From: glen@miller-engineer.com
To: [Senn, Nate](#)
Cc: [SCO; "Matthew J Capone"; Dave.Buff@WSP.com](#)
Subject: NHPC Okeelanta Cogen Facility - Amendment request AM23-286 - Response to RAI letter dated August 18 2023
Date: Thursday, September 28, 2023 10:39:26 AM
Attachments: [PA04-46 Boiler D Amendment RAI response-092823-final-ss.pdf](#)

Licensee: New Hope Power Company
Power Plant: Okeelanta Cogeneration Facility

Siting Certification: PA 04-46

RE: NHPC Okeelanta Cogeneration Facility (PA04-46) Amendment Request (AM23-286)
Package Boiler
Subject: Response to Request for Additional Information letter dated August 18, 2023 (RAI)

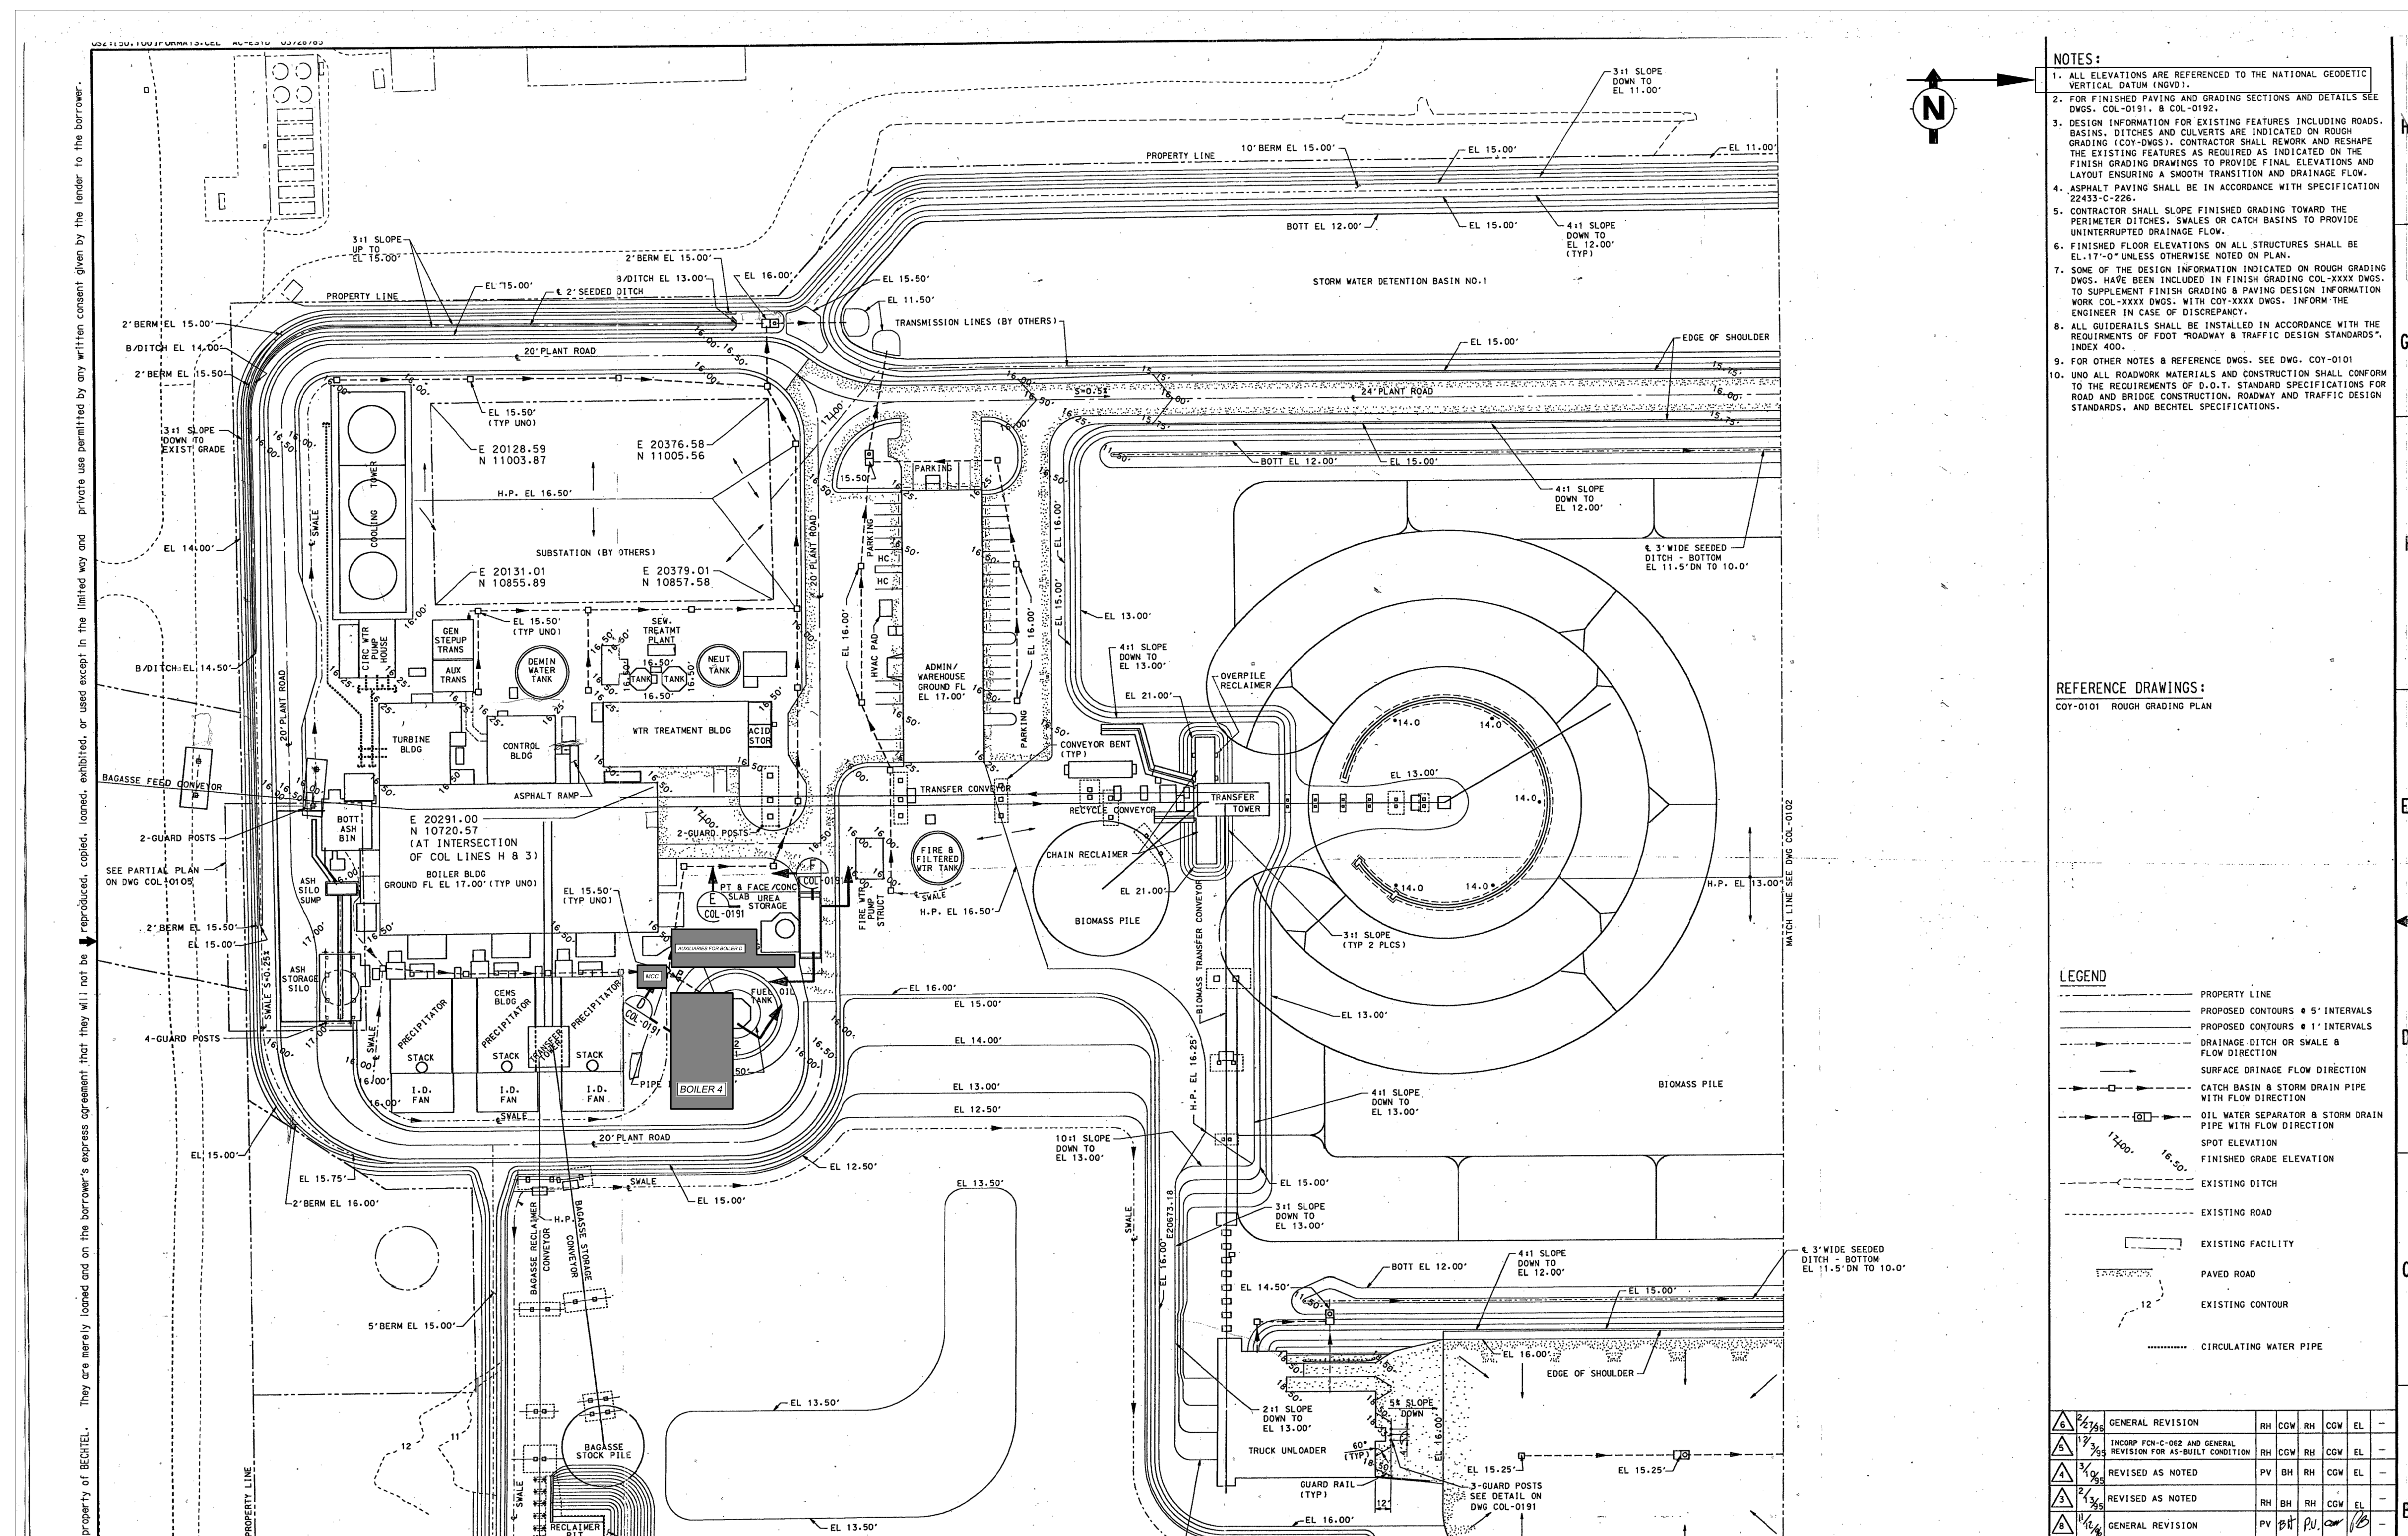
- (3) *Please provide calculations that estimate the industrial wastewater annual average daily flow with the proposed boiler blowdown included. [Conditions of Certification Section B.I.A.2.b.]*

The boiler blowdown is the only industrial wastewater (IWW) flow generated by the gas package boiler process. All IWW flows are disposed of via the active IWW percolation cell. The attached process flow diagram and water balance shows the IWW flows. The estimated AADF to the IWW percolation cell (using the current 3 boilers) is 0.57 mgd and 0.84 mgd during the grinding and non-grinding season, respectively.

Note:
Flows are expressed in thousand gallons per day
Flow number on top are non-grinding season flows.
Flow number on bottom are grinding season flows.

PA04-46C Specific Condition B.I.A.2 limits annual ave IWW flow to 1,100 thousand gal per day.
